Access Compliance Report Public Rights-of-Way (Curb Ramps)

Main Street: PACIFIC_AVE Cross Street: GILBERT_ST Location: NW

ADA ID: RPRK210922122357 Ramp Type: Type 4 - Parallel Initial Pass/Fail: Fail Overall Compliance: No Severity Score: 15

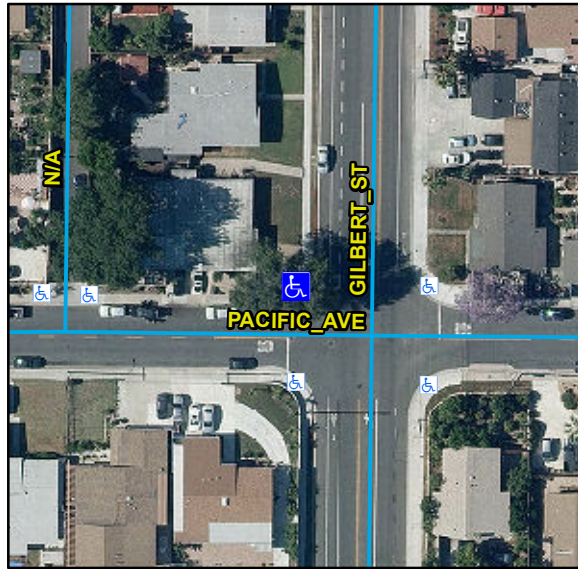
Compliance	Description	Data	Compliance	Description	Data
N/A	Ramp Length LT (in)	60	N/A	Ramp Length RT (in)	60
Yes	Ramp Width LT (in)	54	Yes	Ramp Width RT (in)	60
Yes	Ramp Run Slope LT (%)	6.3	No	Ramp Run Slope RT (%)	9.3
Yes	Ramp Cross Slope LT (%)	1.3	Yes	Ramp Cross Slope RT (%)	1.3
N/A	Landing Present	Yes	N/A	DWS Provided	Yes
N/A	Landing Length (in)	60	N/A	DWS Contrast	Yes
N/A	Landing Width (in)	48	N/A	DWS Length (in)	36
N/A	Landing Run Slope (%)	1.3	N/A	DWS Full Width	Yes
N/A	Landing Cross Slope (%)	1.3		DWS Offset Type	Single
N/A	Landing Movement Obstructed?	No	N/A	DWS Offset Left (in)	0
	Landing Movement Type	Curb	N/A	DWS Offset Right (in)	N/A
N/A	Landing Shared	No			
N/A	Clear Space	Yes			
N/A	Clear Space To Crosswalk (in)	48			
N/A	Marked Crosswalk 1	No	N/A	Marked Crosswalk 2	No
	Crossing 1 Direction	S		Crossing 2 Direction	E
N/A	Marked Crosswalk 1 Width (in)	N/A		Marked Crosswalk 2 Width (in)	N/A
N/A	Ramp Inside Crosswalk 1	N/A	N/A	Ramp Inside Crosswalk 2	N/A

Remove & Replace Curb Ramp With Two New Directional Ramps or Equivalent.
